FINAL DRAFT MINUTES

February 18, 2021 Standards Committee Meeting

RE: Minutes from the February 18, 2021 Standards Committee Meeting

E 801-TCTC-09 MAINTENANCE OF TRAFFIC FOR RPM REFLECTOR REPLACEMENT (WITH MARKUPS)

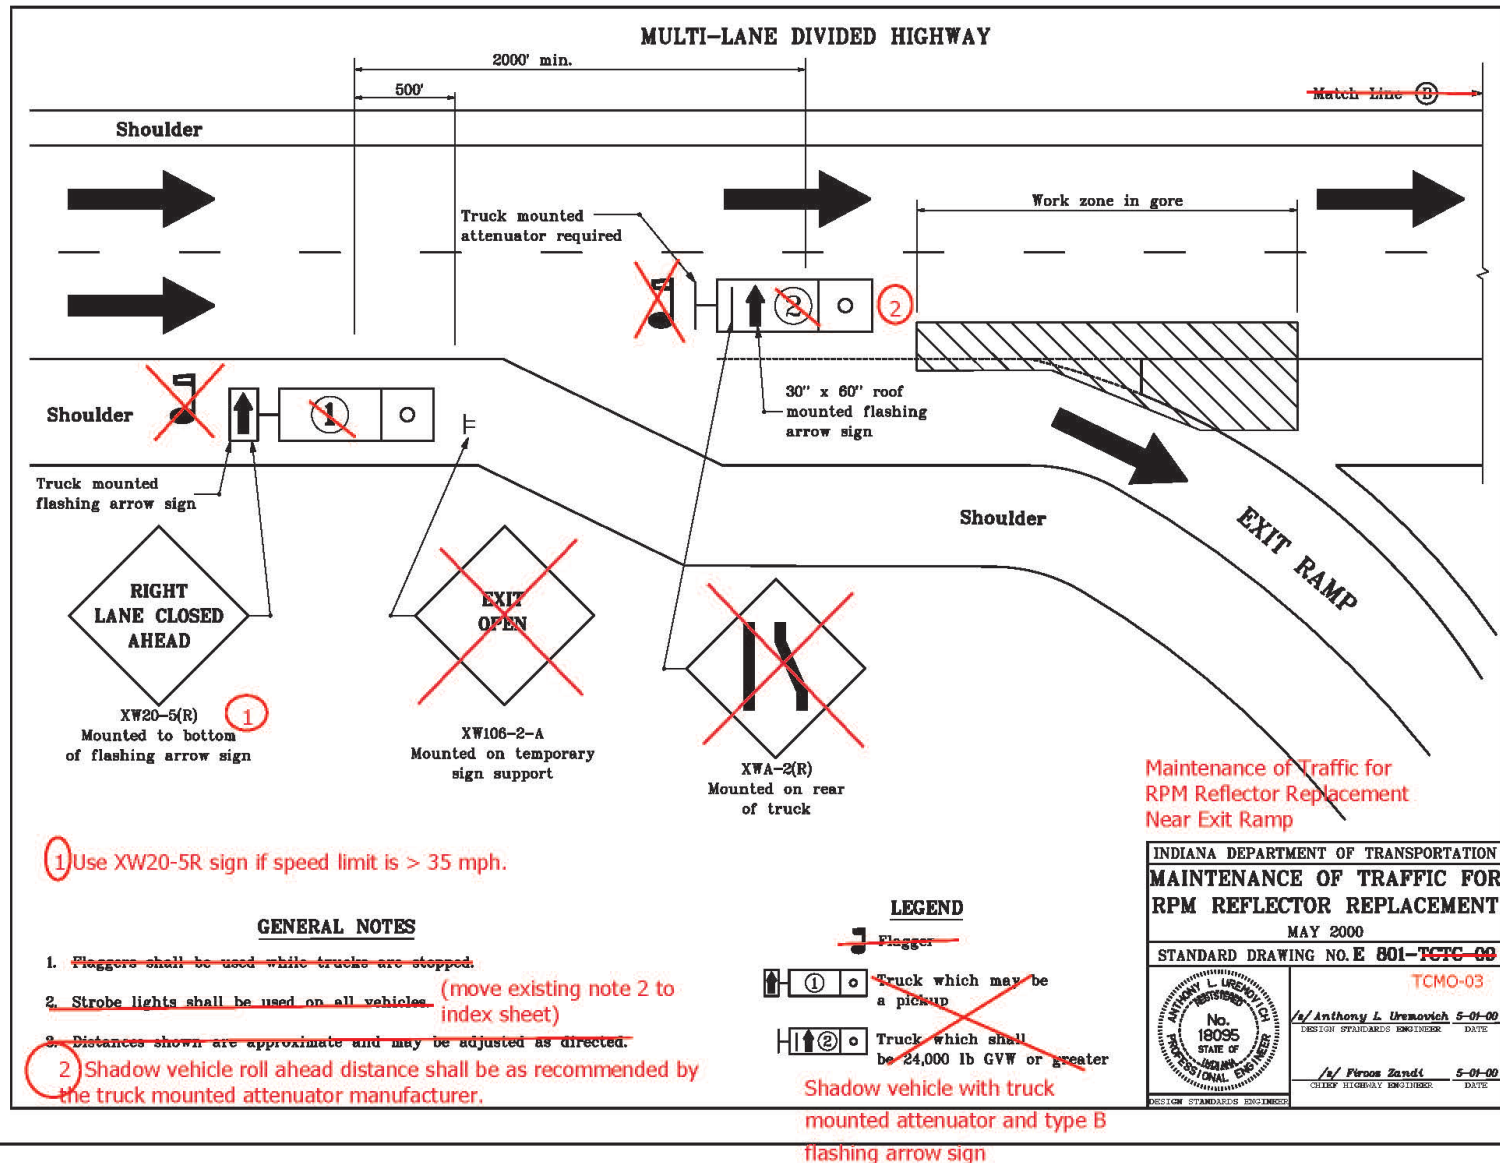
Move to New Series on Traffic Control for Mobile Operations

E 801-TCTC-10 MAINTENANCE OF TRAFFIC FOR RPM REFLECTOR REPLACEMENT (WITH MARKUPS)

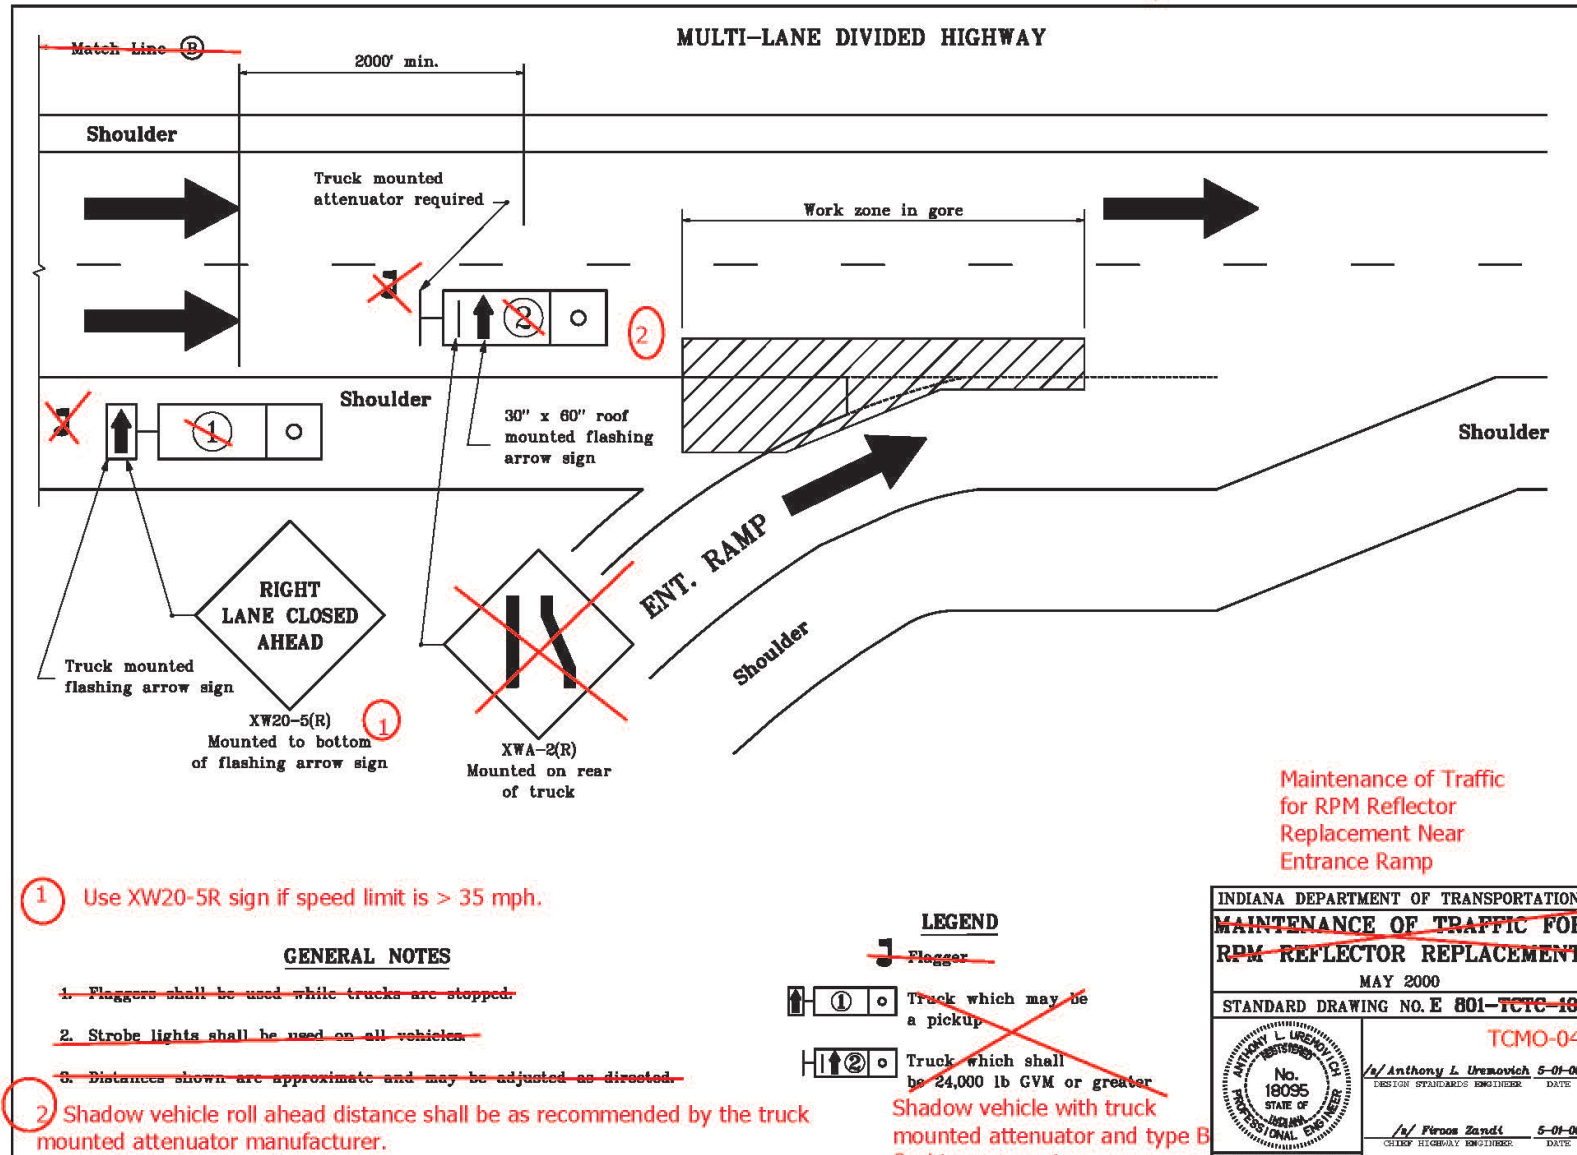
Move to new series on Traffic Control for Mobile Operations
